Ref: **SSD-6249**
WTJ20-432

AMENDMENT REPORT: PROPOSED MATERIALS RECYCLING FACILITY

Cambridge Avenue, Glenfield
Lot 1 DP113201, Lot 2 DP333578, Lot 3 DP736881, Lot 3 DP735524 and Lot 91 DP1155962

—
Prepared by Willowtree Planning Pty Ltd
on behalf of Glenfield Waste Services

Figure 1. Site Plan (Source: L Form Architects, 2022)

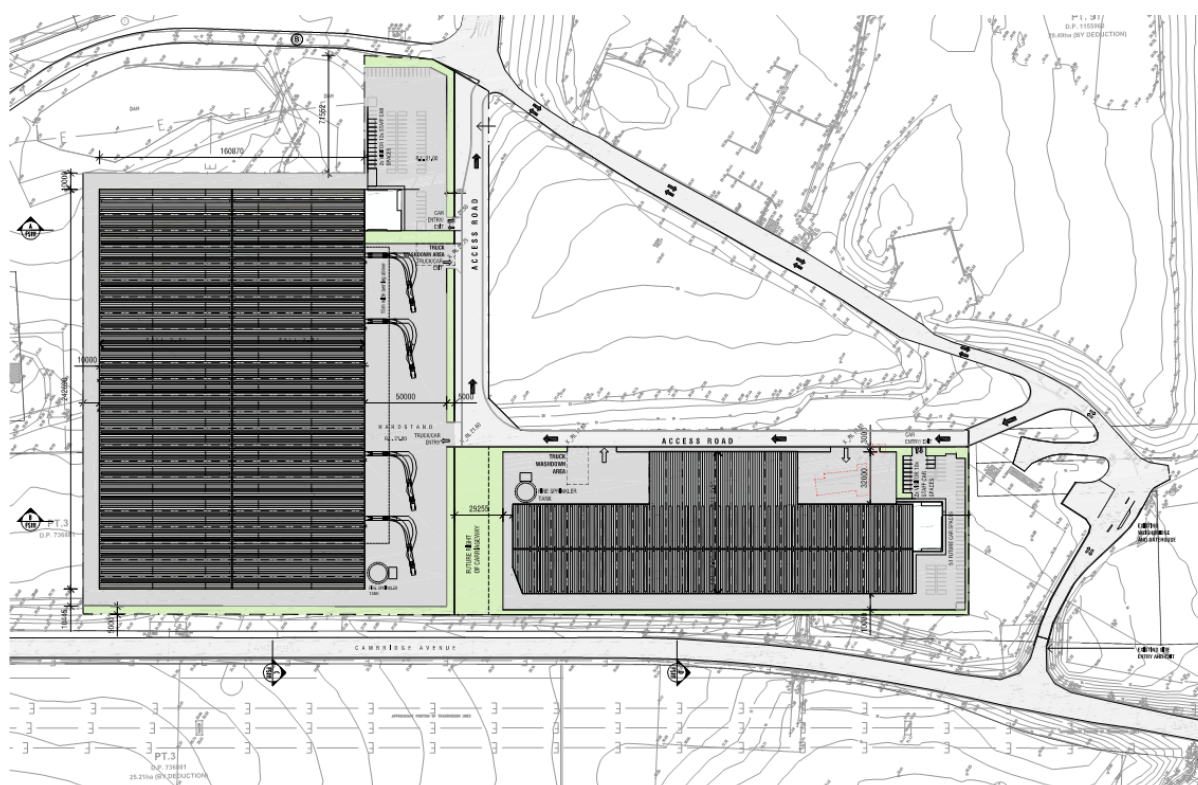
In response to the consultation undertaken with DPE throughout 2022, the proposed development has been amended to be significantly reduced in scale. The following subsections outline the project amendments and an updated environmental assessment and/or commentary.

The layout and design of the proposal as amended is shown in the Architectural Drawings at **Appendix B1**, and the Site Plan is provided in **Figure 1** below.

Figure 11. Proposed Soil and Water Management Infrastructure (Source: Edison, 2022)

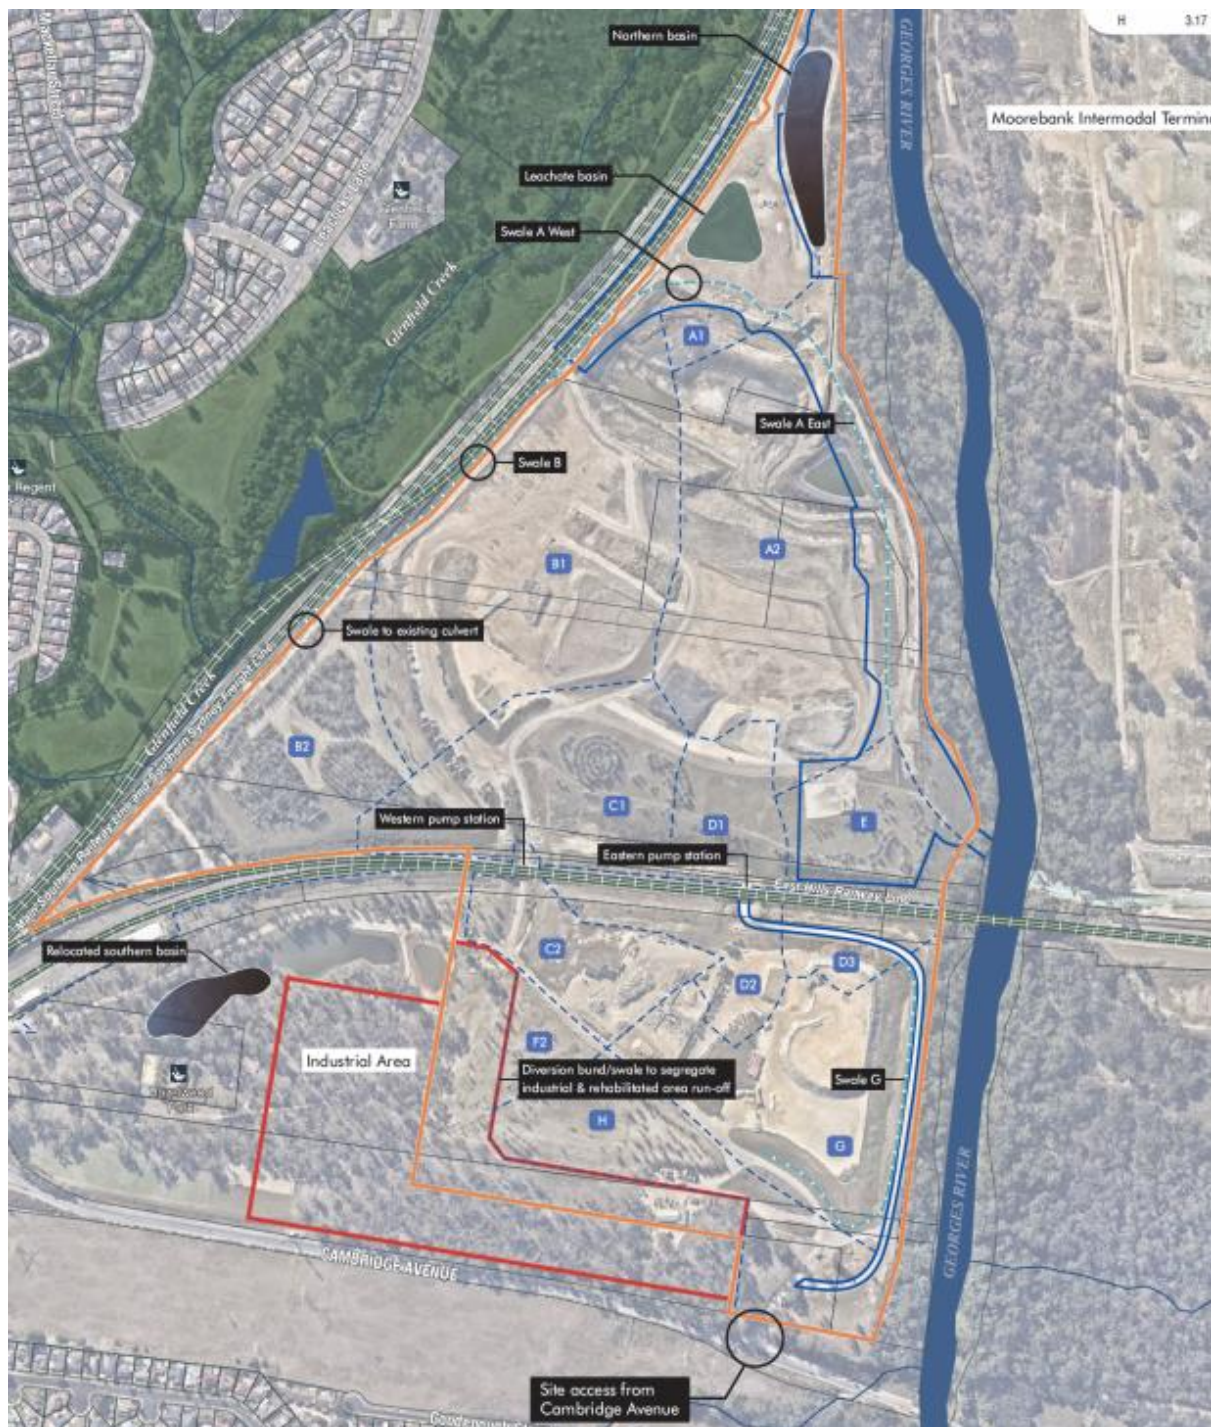
For reference, the **Figures 10** and **11** below demonstrate the existing and proposed soil and water management infrastructure for the Subject Site.
